8.2 Master Responses

8.2.1 Master Response 1: EIR/EIS Authorship

8.2.2 Master Response 2: Source Water Components and Definitions

Figure 8.2.12-1
 Extended NMGWM²⁰¹⁶

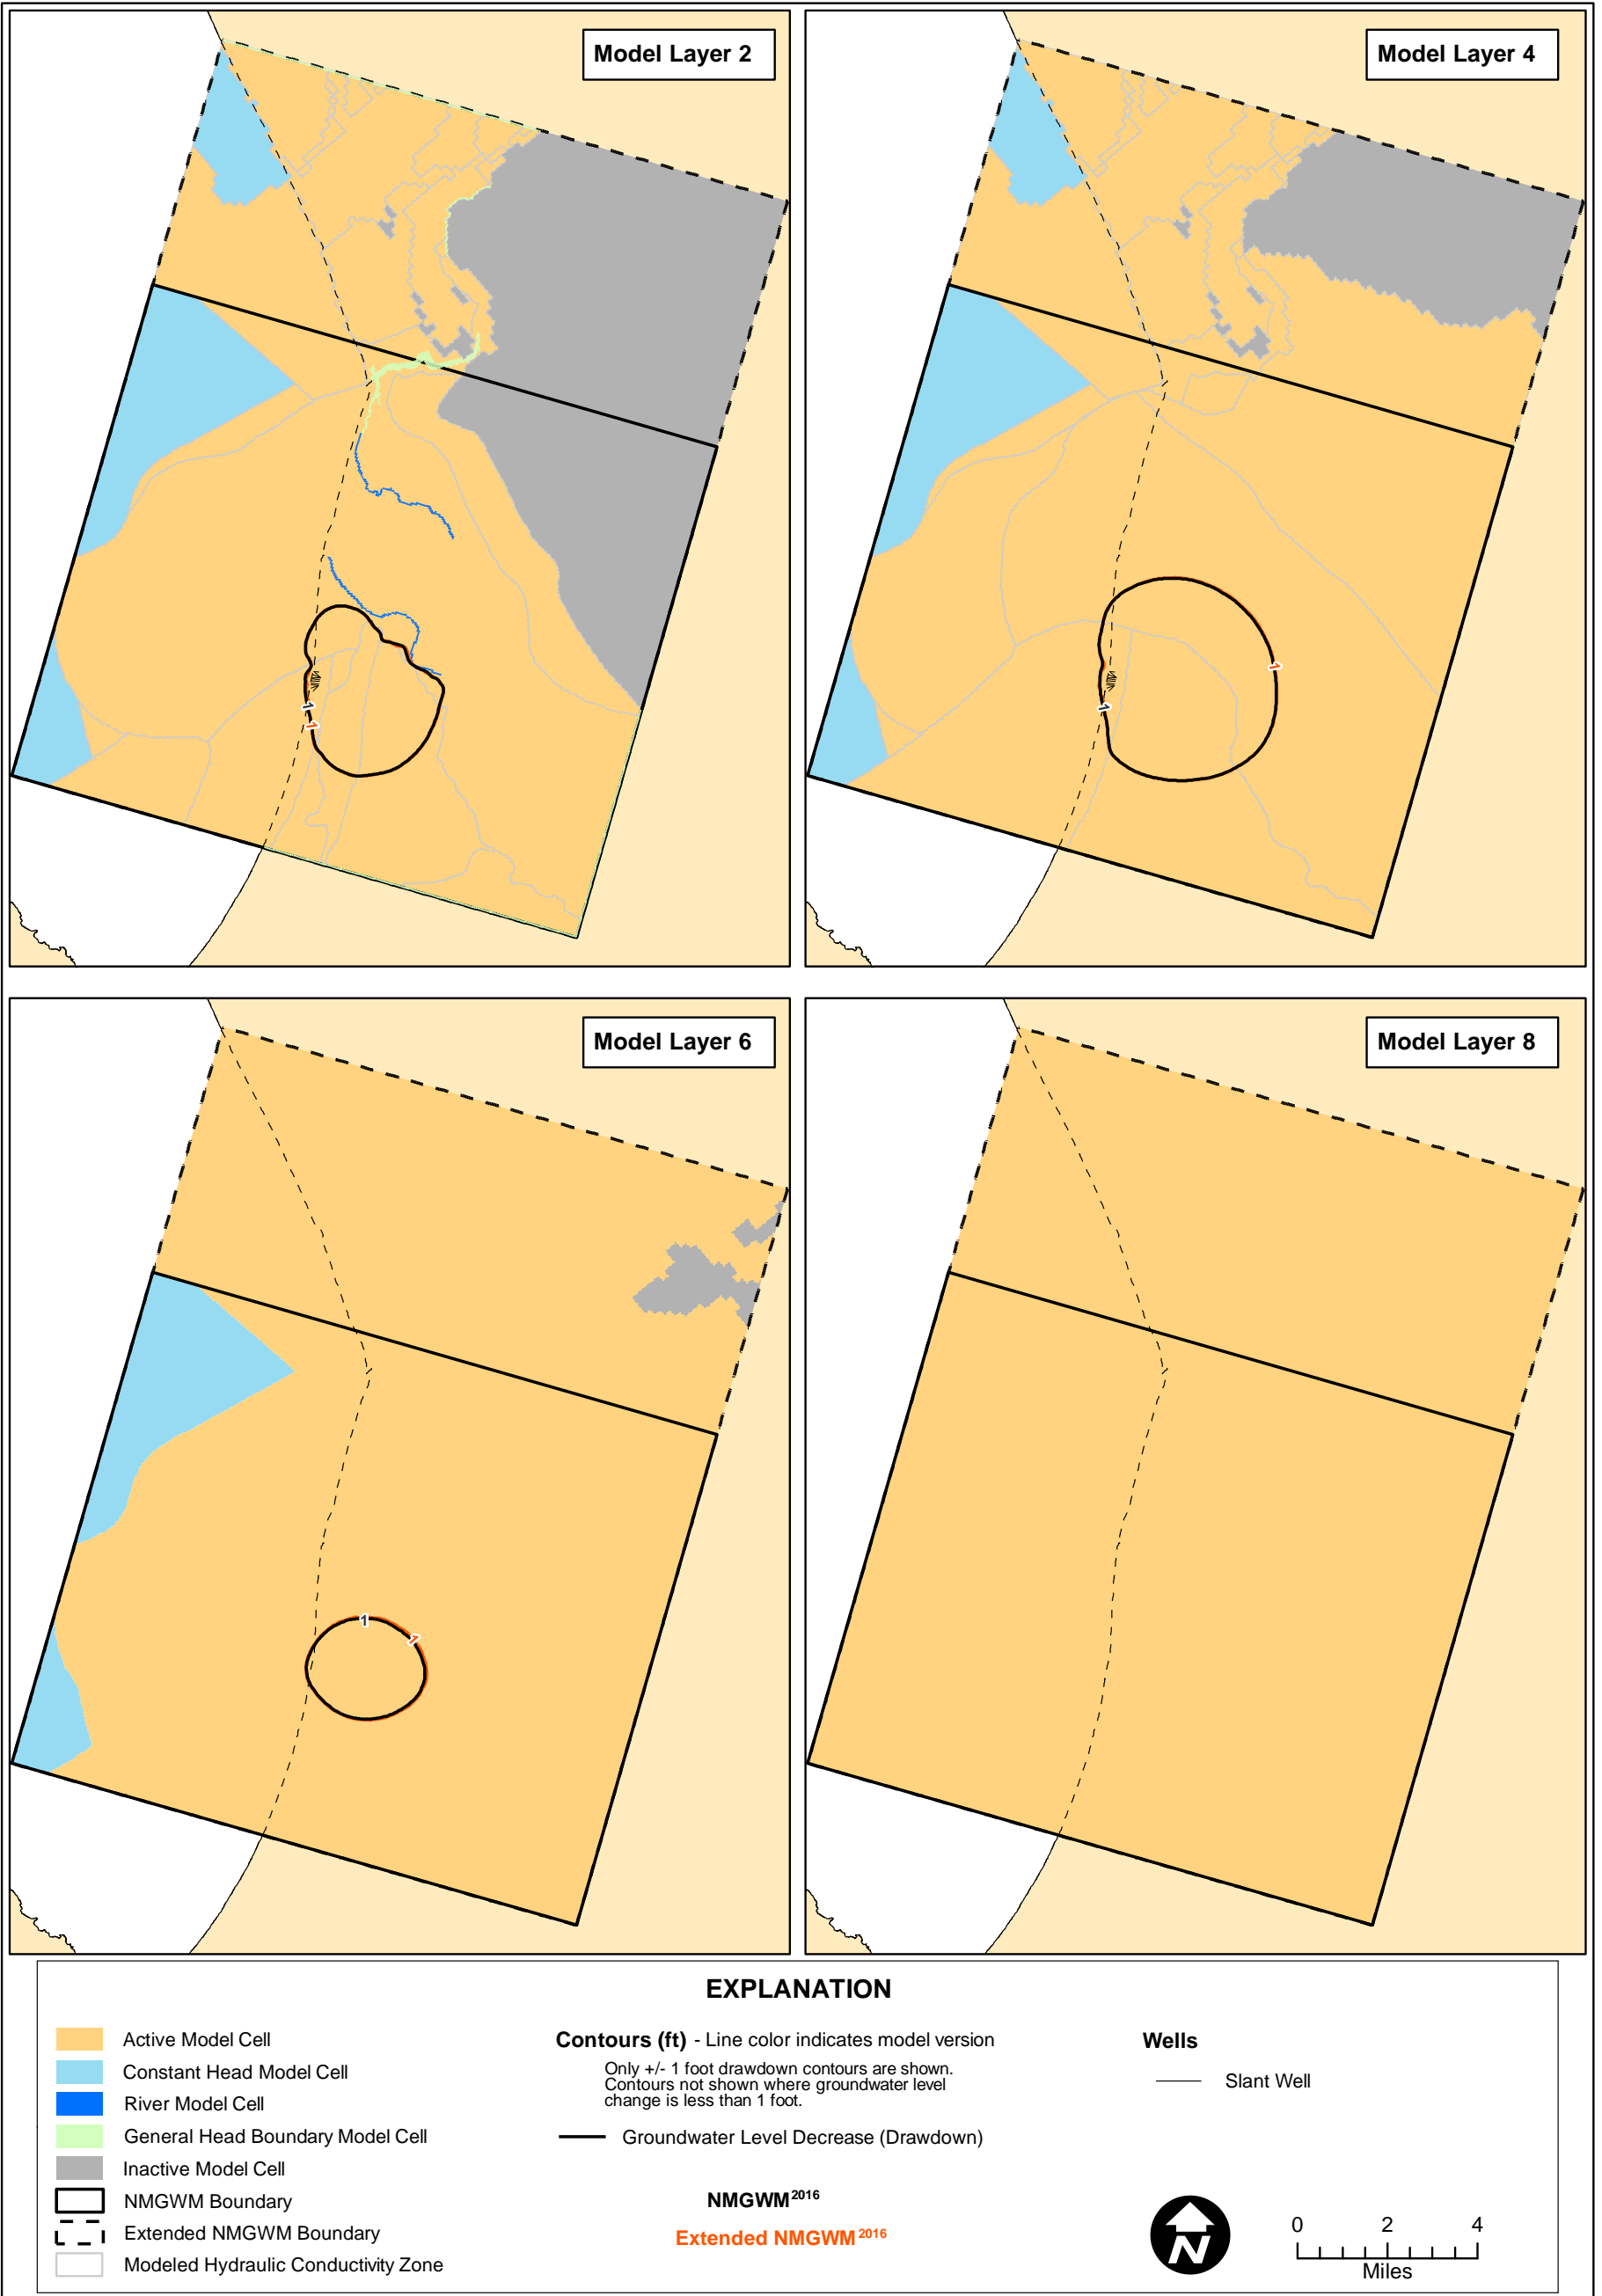
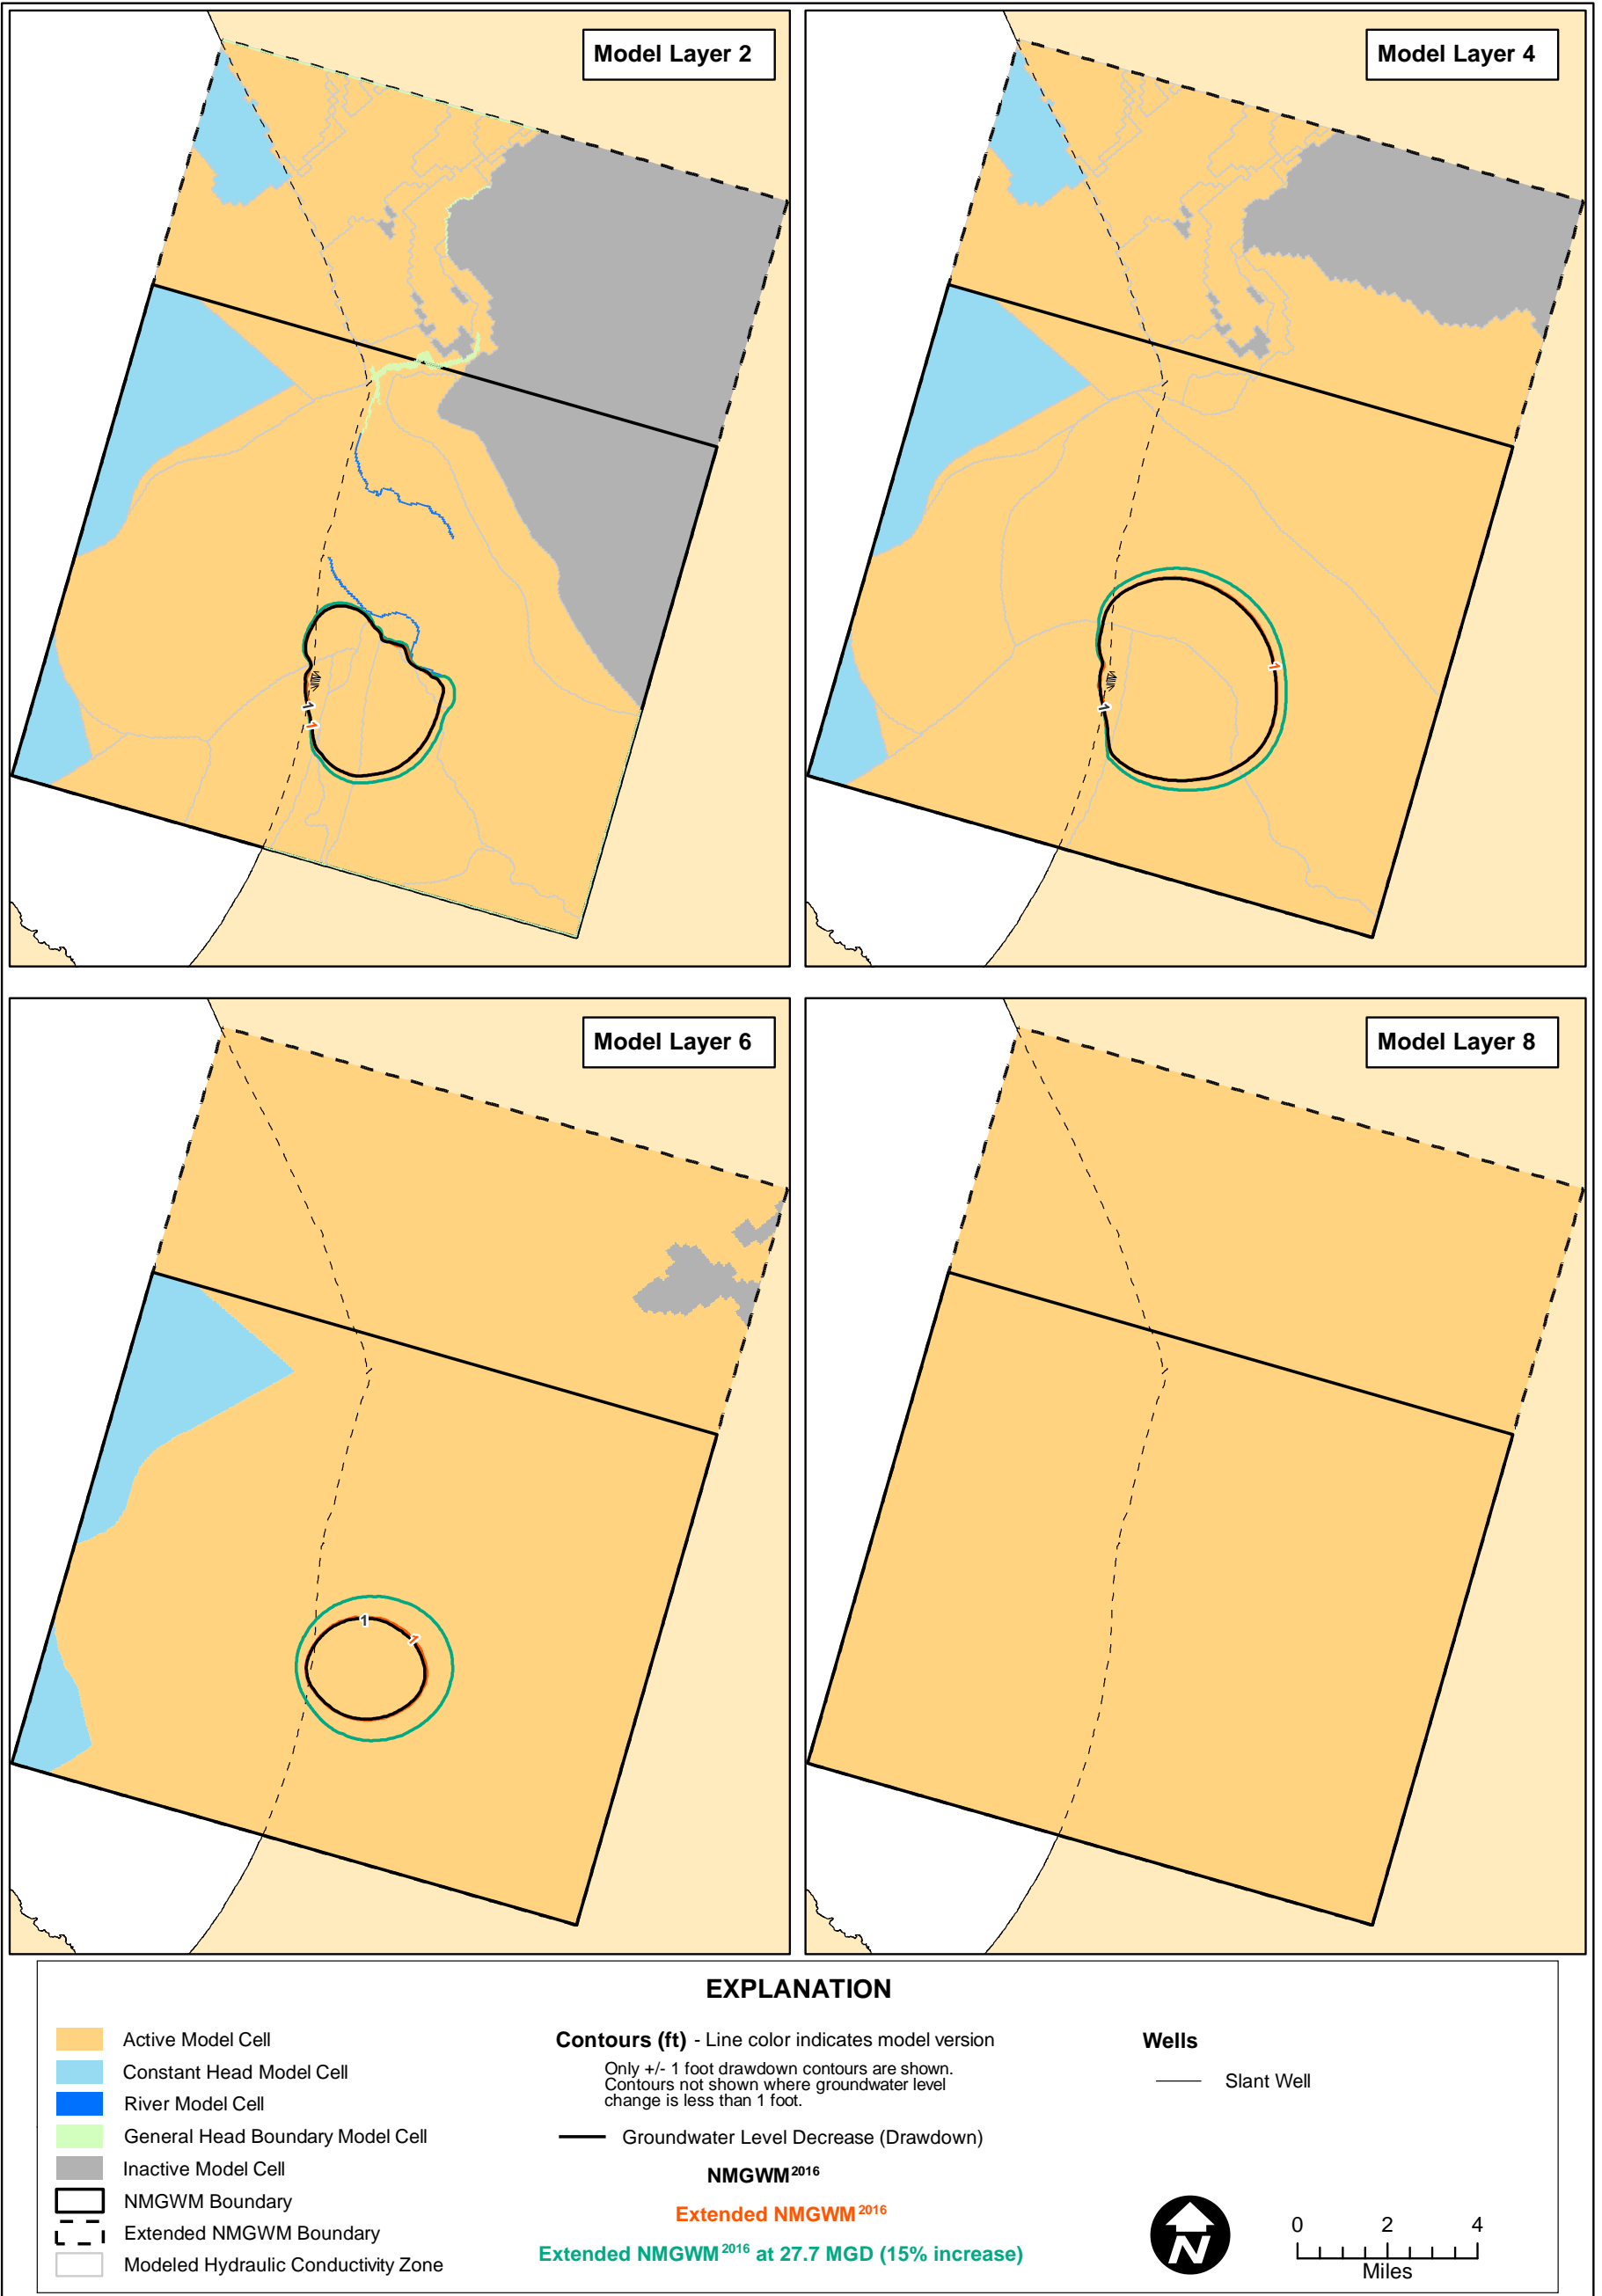
The NMGWM²⁰¹⁶ was employed to calculate the cone of depression for slant well pumping at the CEMEX and Potrero Road sites. Multiple model tests confirmed that the NMGWM²⁰¹⁶ results are not substantially influenced by the head-dependent flux boundaries. In one test, the cone of depression calculated with the NMGWM²⁰¹⁶ (24.1 mgd) was shown to be the same as the cone of depression calculated by an extended version of the NMGWM²⁰¹⁶ (see **Figure 8.2.12-1**). The “Extended Model” is described in Attachment 2 of Appendix E2 “Simple Expanded Test Model,” and its northern head-dependent flux boundary is located approximately 5.5 miles north of the NMGWM²⁰¹⁶ boundary. Hence, two models having different boundary configurations produced the same cone of depression, confirming that the NMGWM²⁰¹⁶ boundary locations do not reduce model-calculated drawdown. As another test, HydroFocus increased the pumping rate from 24.1 mgd to 27.7 mgd (an increase of 15 percent), and results showed the expected expansion of the cone of depression within the model domain (see **Figure 8.2.12-2**). These results confirm that the NMGWM²⁰¹⁶ boundaries did not reduce the extent of the cone of depression from pumping at the CEMEX site. The same comparisons for the Potrero Road Site indicated that the cone of depression is modestly influenced by the northern boundary location, but the effect is fairly insignificant for making drawdown comparisons between the CEMEX and Potrero Road Sites (see Attachment 2 of Appendix E2).

The NMGWM²⁰¹⁶ includes the A-Aquifer and Fort Ord Salinas Valley Aquitard (FO-SVA) in model layers 2 and 3, respectively. These units are not considered in the 2015 version of the NMGWM (referred to herein as NMGWM²⁰¹⁵) and in SVIGSM, both of which supported the analysis in the April 2015 MPWSP Draft EIR. Their inclusion in the NMGWM²⁰¹⁶ is consistent with recommendations made by the LBNL based on its review of the NMGWM²⁰¹⁵, but their inclusion was also identified and was implemented independently by HydroFocus. Drawdown due solely to pumping is dependent primarily on the pumping rate and the water transmitting and storage properties of the aquifer (Driscoll, 1986; Bear, 1979). Hence, because the NMGWM²⁰¹⁶ is a more accurate representation of the hydrostratigraphic framework in the Fort Ord area (because it includes the A-Aquifer and FO-SVA), it provides more reliable drawdown results than the NMGWM²⁰¹⁵ and SVIGSM.
